**SOUTH PLUME GROUNDWATER RECOVERY SYSTEM DESIGN,
MONITORING, AND EVALUATION PROGRAM PLAN SYSTEM
EVALUATION REPORT FOR DECEMBER 1993 THROUGH FEBRUARY
1994 - REV 1**

**AUGUST 1994
REVISION 1**

Appendix B
Response to OEPA Comments
Submitted July 15, 1994
on
South Plume Groundwater Recovery System
Design, Monitoring and Evaluation Program Plan,
System Evaluation Report

FIGURE 3.2-7

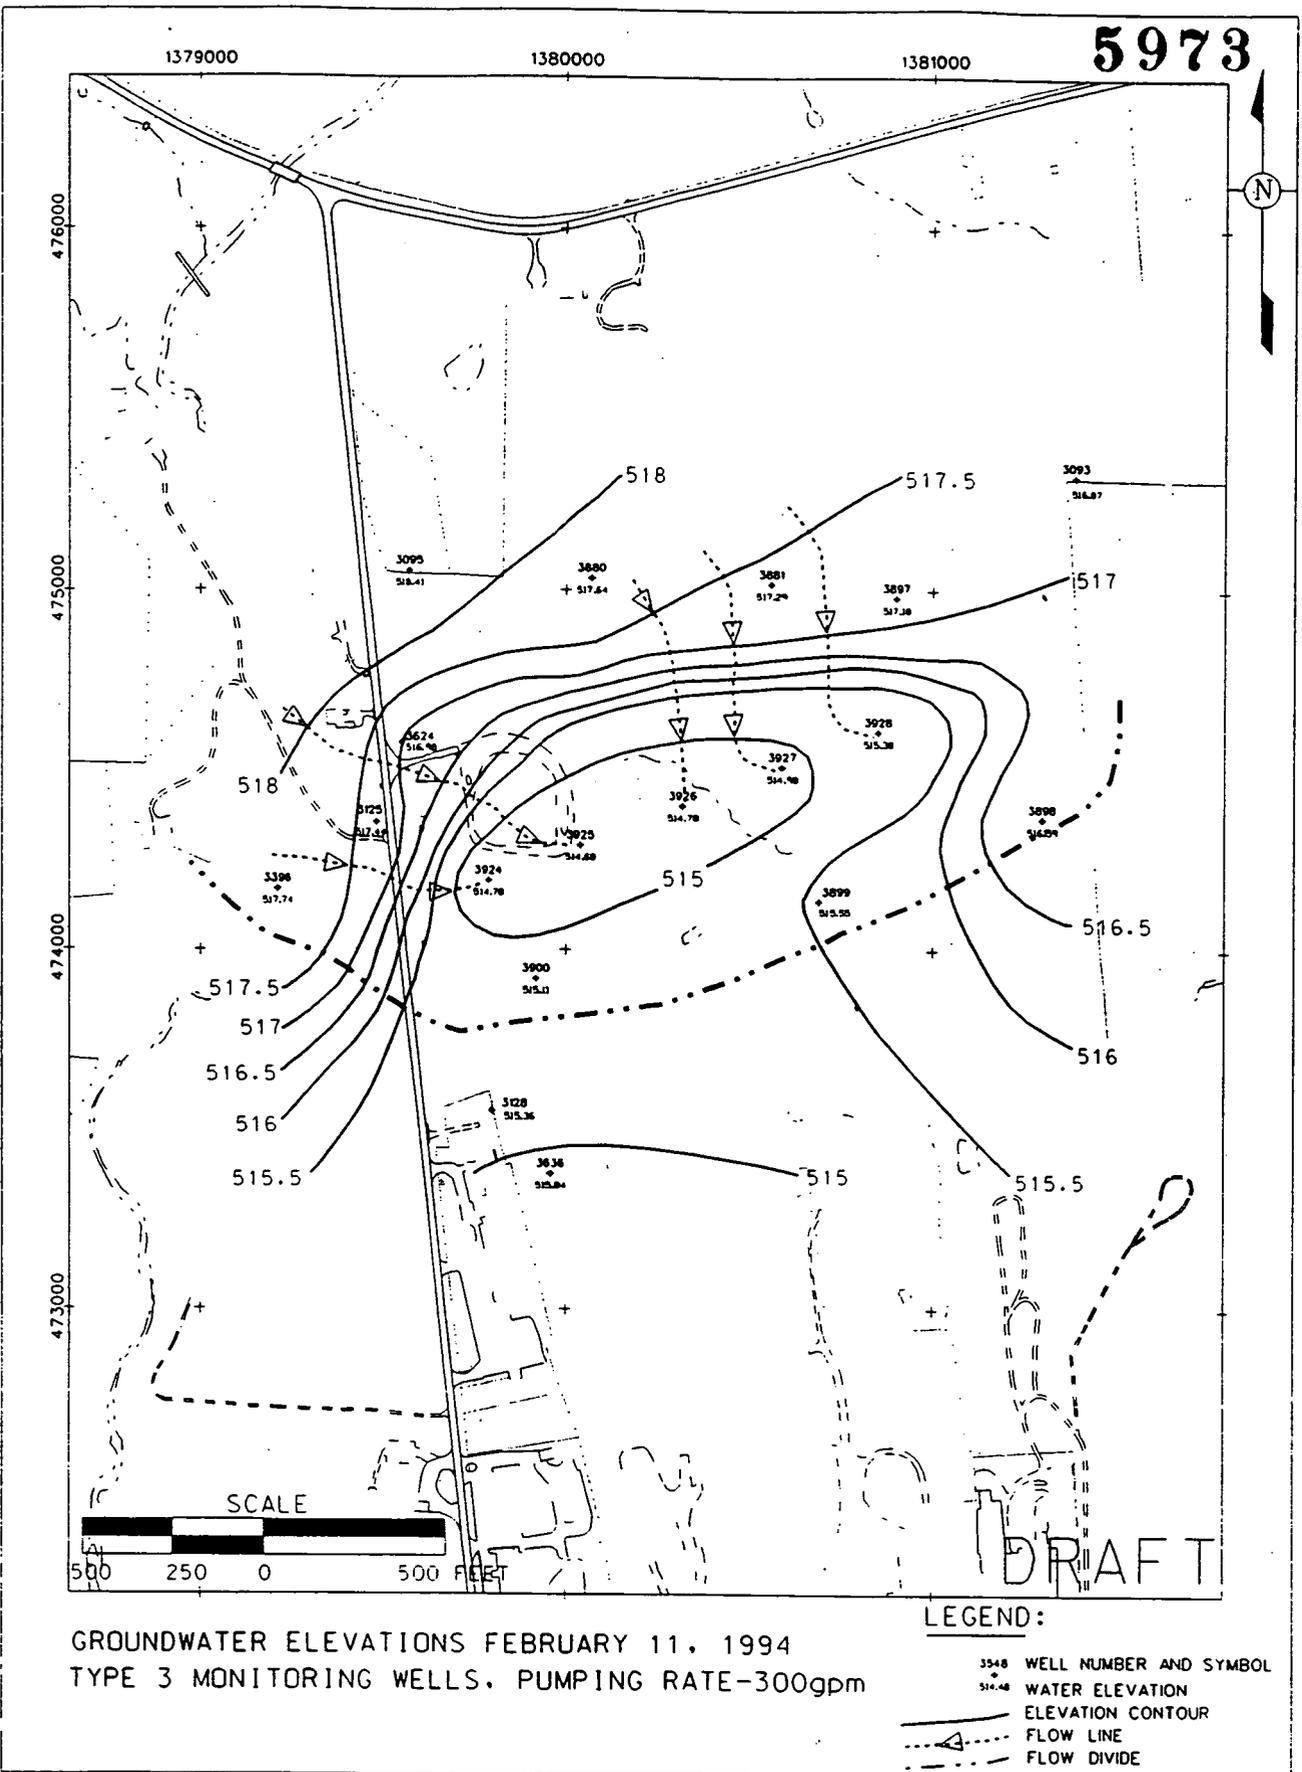
There is no assessment of the vertical extent of the capture zone (the capture volume) in the report. Is the extent of the capture presumed to be invariate with depth? What do the data show? What does the model suggest? Why are there no hydraulic head contour maps of 3000 series well data?

Please see section 3.2 Capture Zone Analyses. This section presents hydraulic head contours for Type 3 well data compared to Type 2 well head contours. It also presents modeled particle tracks for model layers 1, 3 and 5 in planar form and vertical cross sections of particle tracks from model layer 1 through 5.

FIGURE 3.2-16

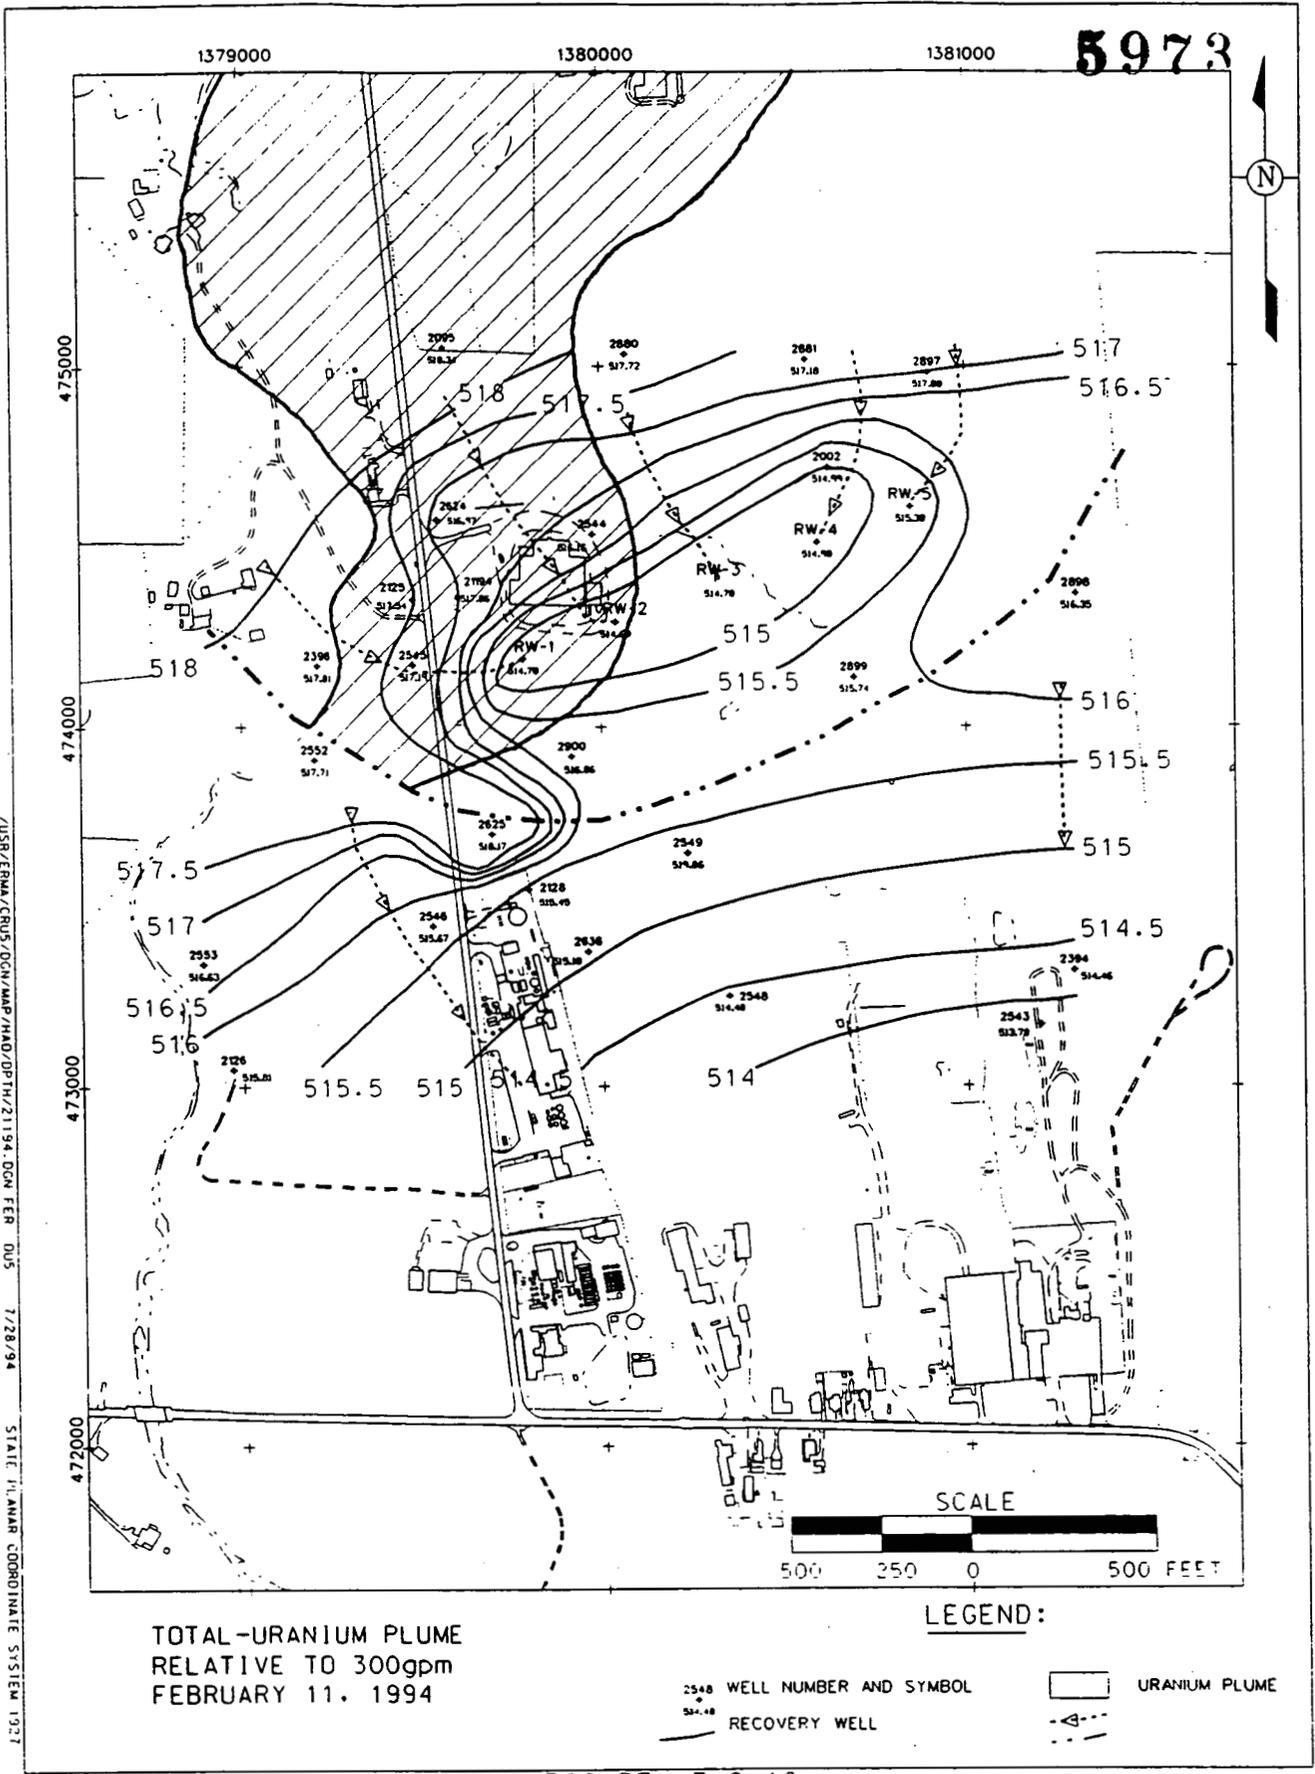
This figure implies that monitoring well 3924 is in a zone with uranium concentrations below 5 ppb. The figure needs to be revised to reflect the western component of the uranium plume.

Agreed. The footprint of the 5 ppb uranium plume has been extended to the flow divide of the capture zone to show where the recovery wells lie relative to the uranium plume. See figure 3.2-16.
